Rebuttal Proof of Evidence re MKC of Martin J Paddle BSc
CEng CWEM MICE FCIHT MCIWEM, in regard to Transport,
Highway and Accessibility Matters: PINS ref:
APP/Y0435/W/20/3252528 LPA ref: 15/00619/FUL

**OUR REF. NO. SWMK: REBUTTAL PROOF OF EVIDENCE RE MKC OF MARTIN J
PADDLE**

DATE: 27 APRIL 2021

Figure 5-10 - Junction 16: Elfield Park Roundabout AM Peak Maximum Queue Lengths

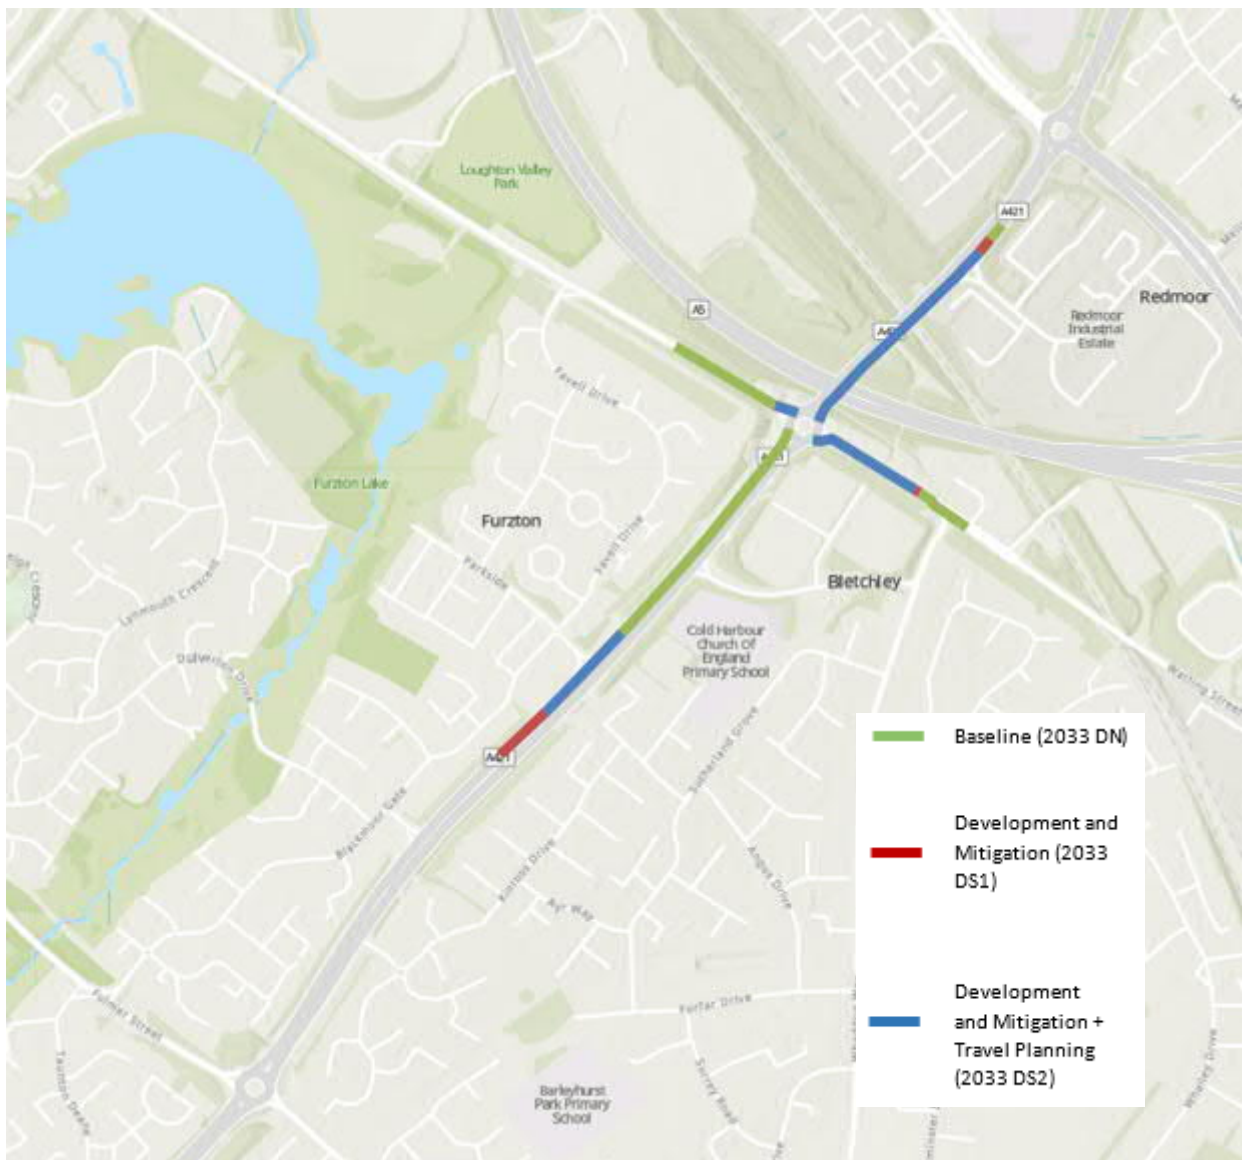
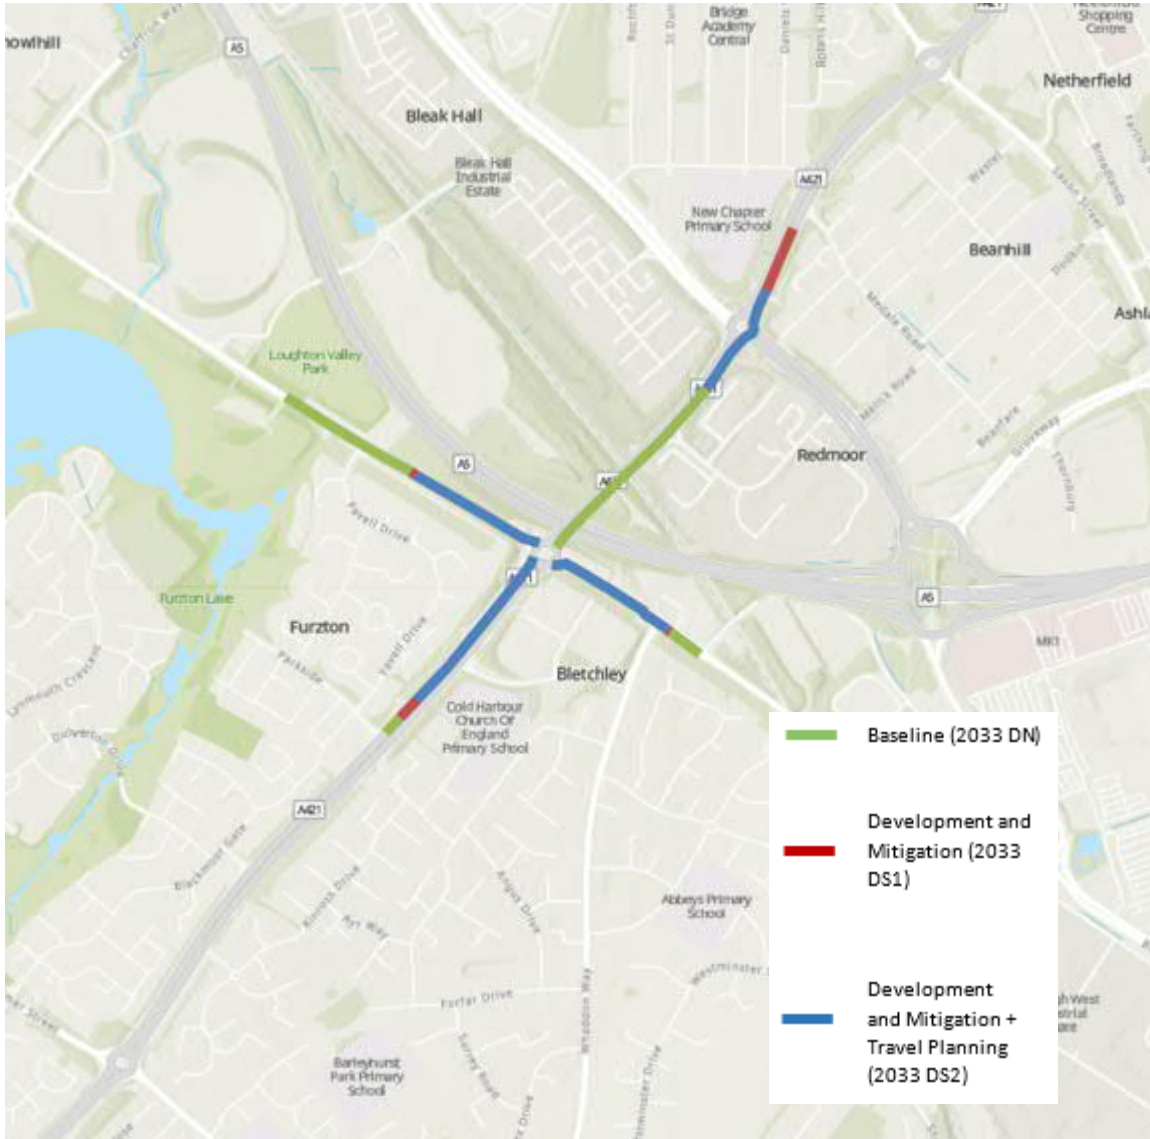
5.57 I refer to paragraphs 6.4.59 to 6.4.71 and Figures 6.9 and 6.10 of Mr McKechnie’s main Proof. Again, the information presented regarding queue lengths differs from our own analysis. Without an explanation of the methodology used, I can only conclude that Mr McKechnie’s figures are incorrect and misleading. **Figures 5-10** and **5-11** of this Rebuttal Evidence present my team’s analysis of queue lengths for the AM and PM peaks.

5.58 **Figures 5-10 and 5-11** demonstrate that overall, there is a benefit in junction queuing in the AM and PM peak periods. The only possible potential interaction of vehicles between junctions 16 and 15 would be in the PM peak on the northern arm of A421. In the context of the urban highway network that serves Milton Keynes, which is not dissimilar to many other congested metropolitan areas, the queue shown on A421 in 2033 in the DS1 post mitigation scenario is in my opinion acceptable.

Figure 5-12 - Junction 17: Emerson Roundabout Mitigation Proposal

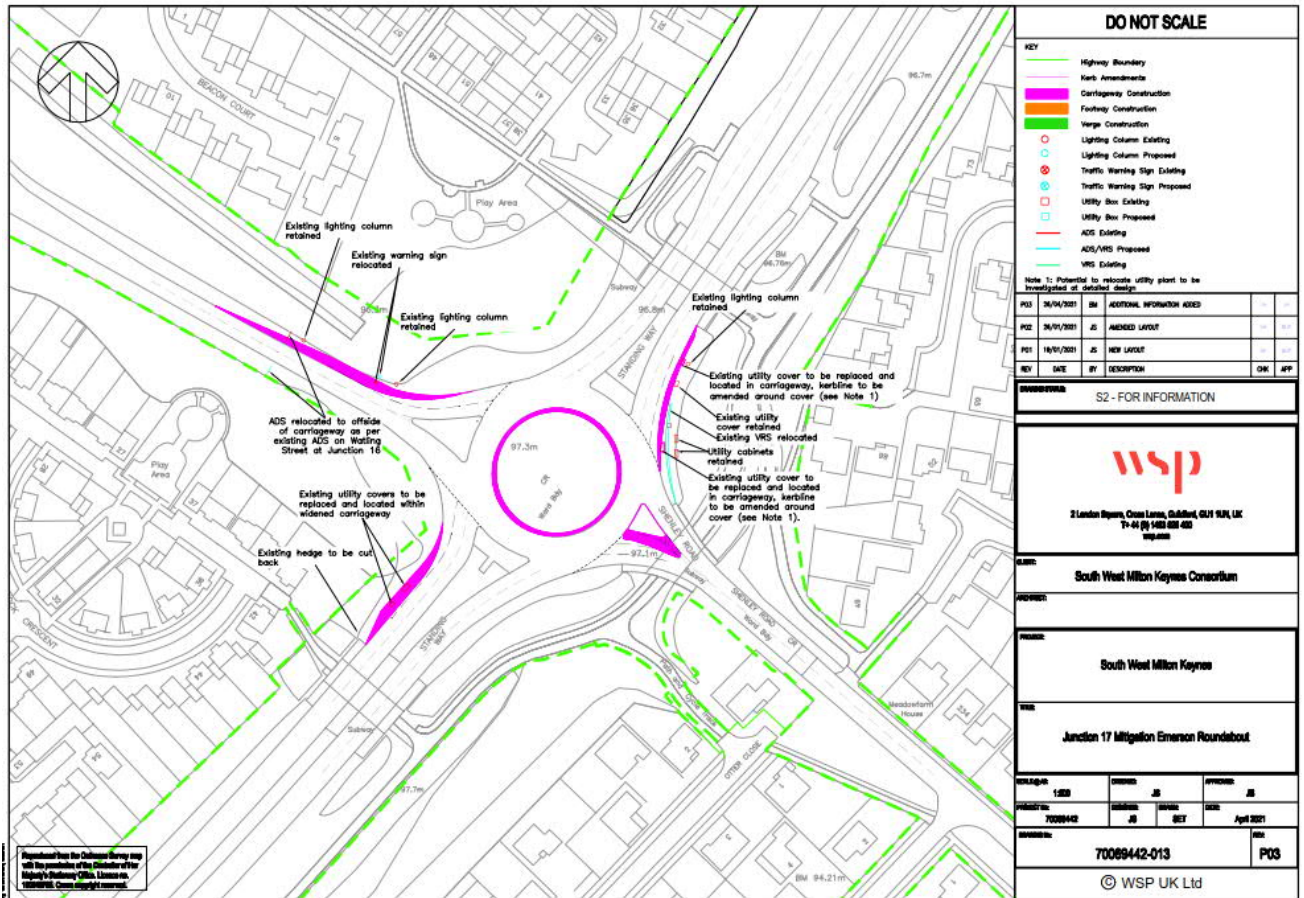
- 5.63 With reference to paragraph 6.4.79 of Mr McKechnie's main Proof where he mentions a "*sharp flare*", no issue has been raised by the RSA and I consider this to be acceptable and safe. In respect of the existing vegetation and utilities on this arm, the vegetation can easily be removed as it is currently over-grown and clearly not maintained. Additional information is provided to illustrate how the existing street furniture would be relocated within the scheme. This additional detail is shown in **Figure 5-12** and Appendix MJP42.

Figure 5-13 - Junction 17: Emerson Roundabout PM Peak Maximum Queue Lengths

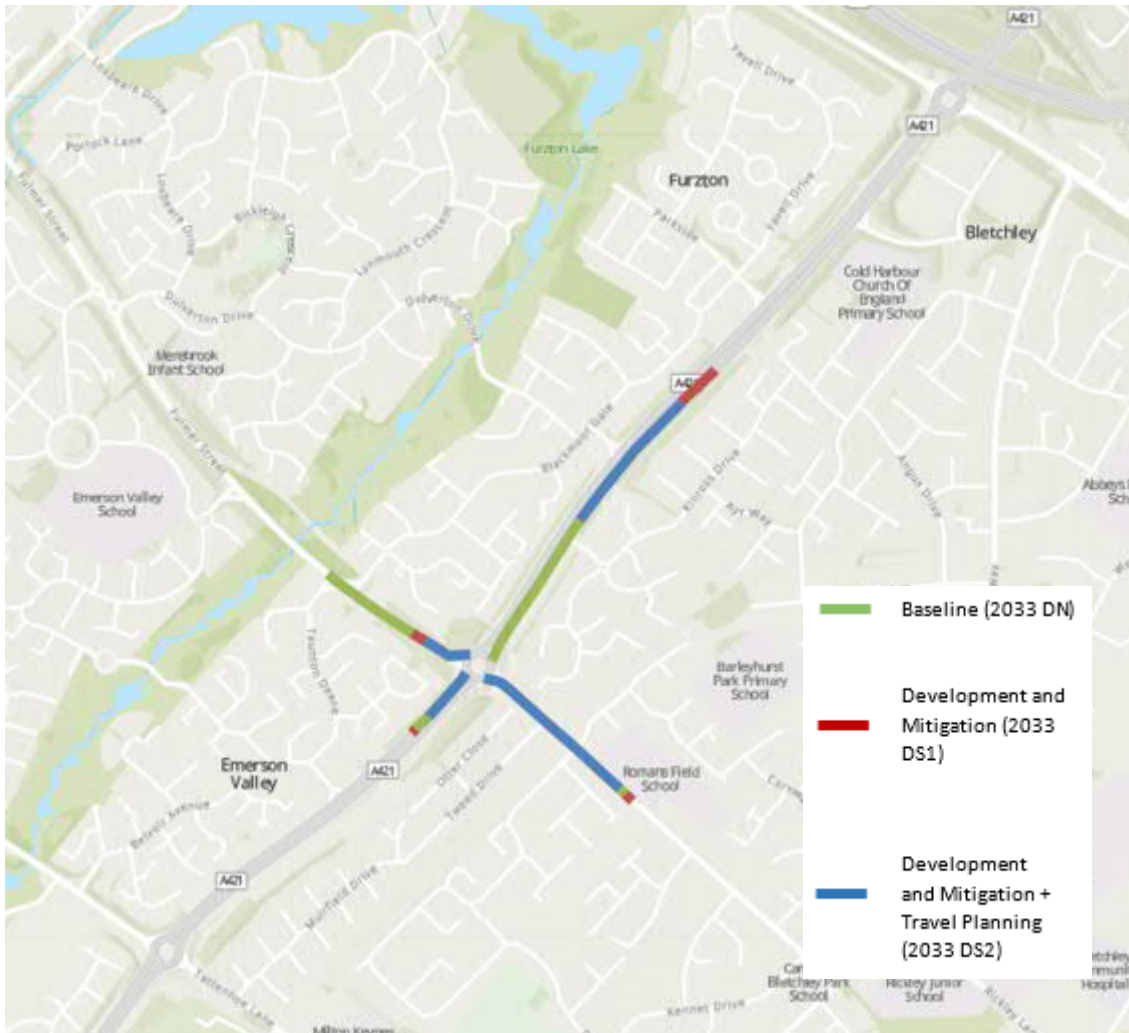
5.66 In respect of paragraphs 6.4.85 to 6.4.87 and Figure 6.11 of Mr McKechnie’s main Proof, the queue analysis suggested is incorrect and misleading, as I detailed earlier. My team’s analysis of the potential queuing is presented in **Figure 5-13** for the PM peak which shows that there would be no blocking back of queues to Junction 16.

Figure 5-14 - Junction 18: Windmill Hill Roundabout Mitigation Proposal

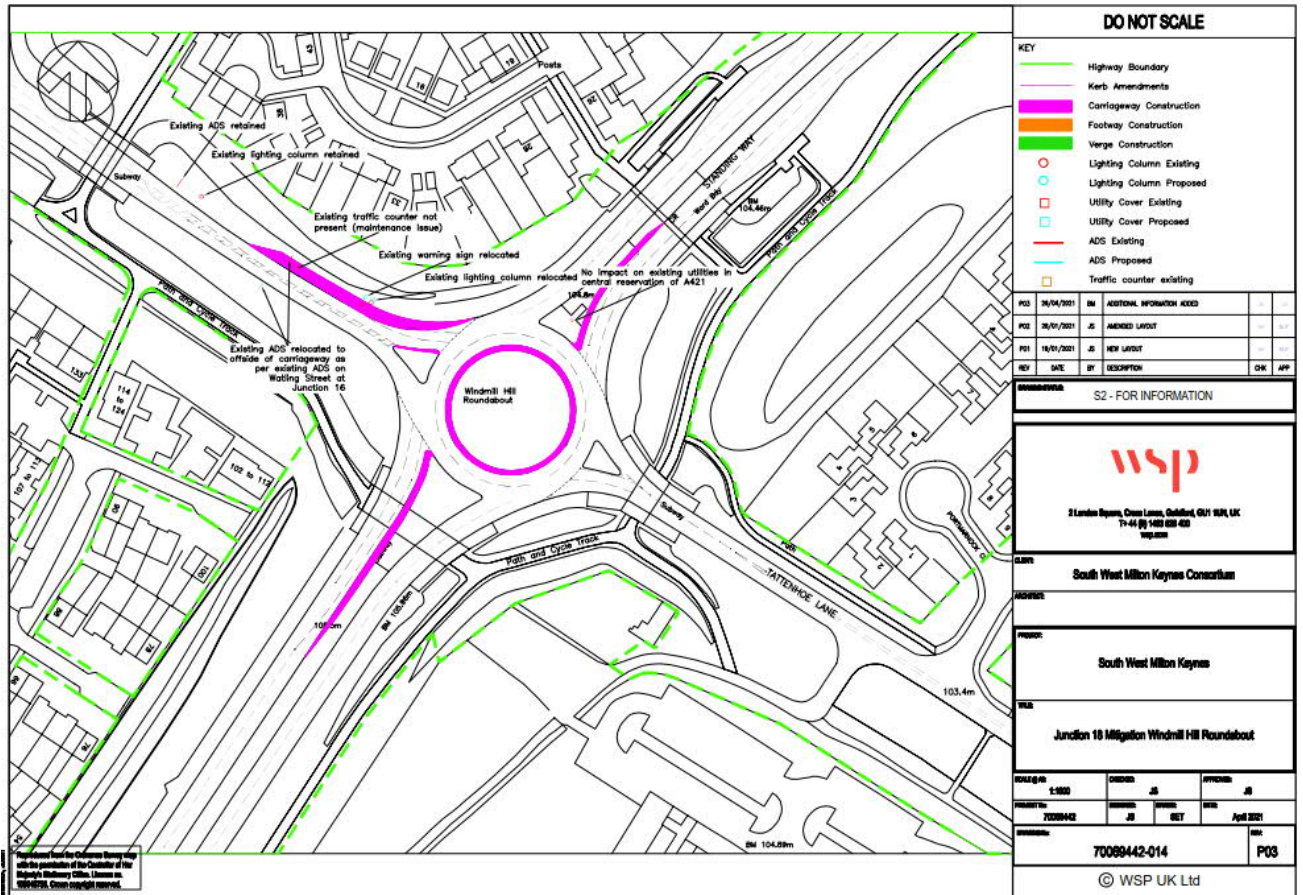
5.67 I refer to paragraph 6.4.90 and 6.4.91 of Mr McKechnie’s main Proof and provide a layout plan showing additional detail (with no change to the mitigation proposals) to demonstrate how the street furniture would be accommodated within the scheme proposals. (Figure 5-14 and Appendix MJ43). **Figure 5-14** demonstrates that the mitigation proposals do not require amendment and are deliverable.

Figure 5-15 - Junction 18: Windmill Hill Roundabout PM Peak Maximum Queue Lengths

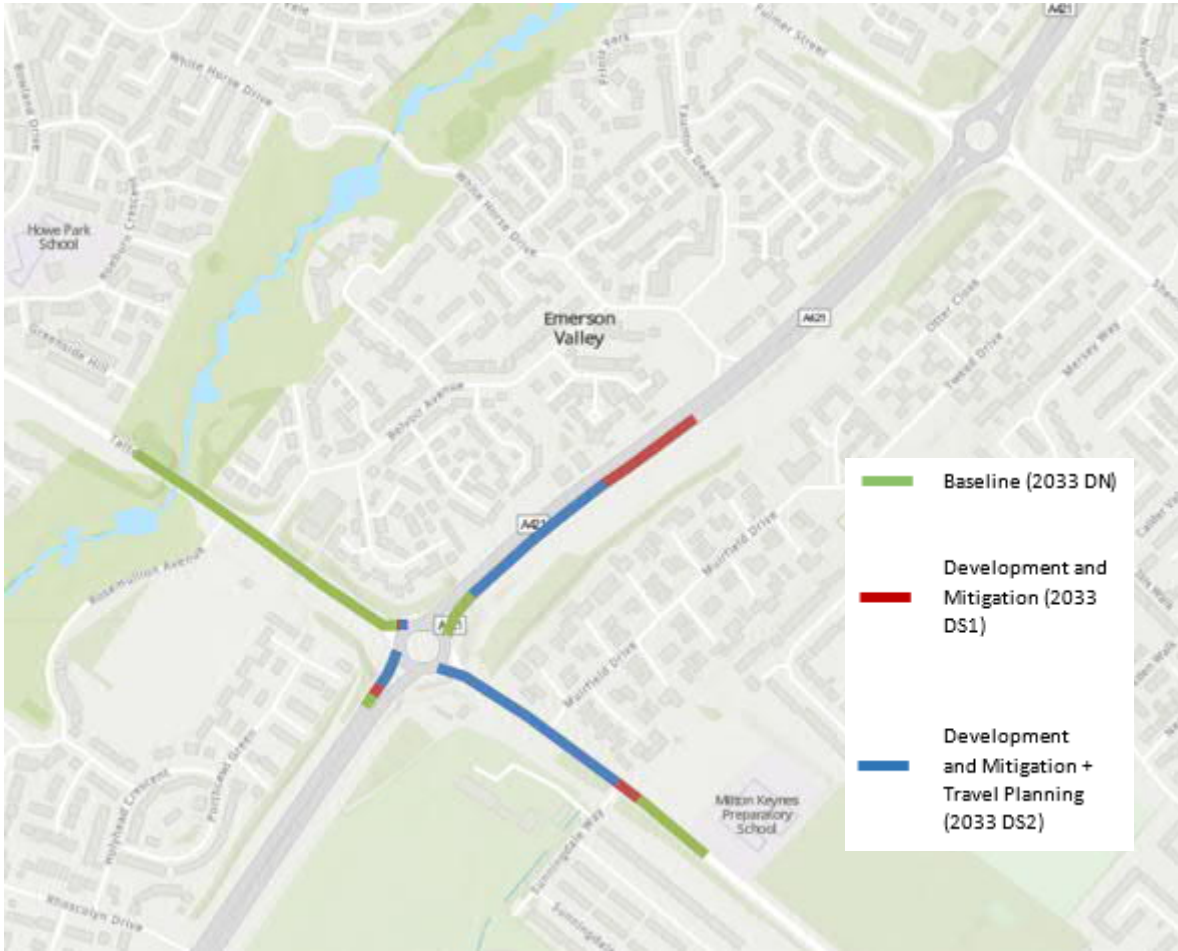
- 5.68 I refer to paragraph 6.4.92 of Mr McKechnie's main Proof. Swept path analysis was completed and is provided in MJP20 to demonstrate that the widening would not result in a safety issue on the highway network. With minor amendments to signage and lining to be included at detailed design, the RSA conclude the junction proposals are safe.
- 5.69 With reference to paragraph 6.4.94 and Figure 6.12 of Mr McKechnie's main Proof, the extent of queuing suggested is incorrect and misleading. As previously, **Figure 5-15** shows that there would not be any interaction between junctions, and that queuing on three arms of the roundabout would be significantly improved as a result of the proposed mitigation.
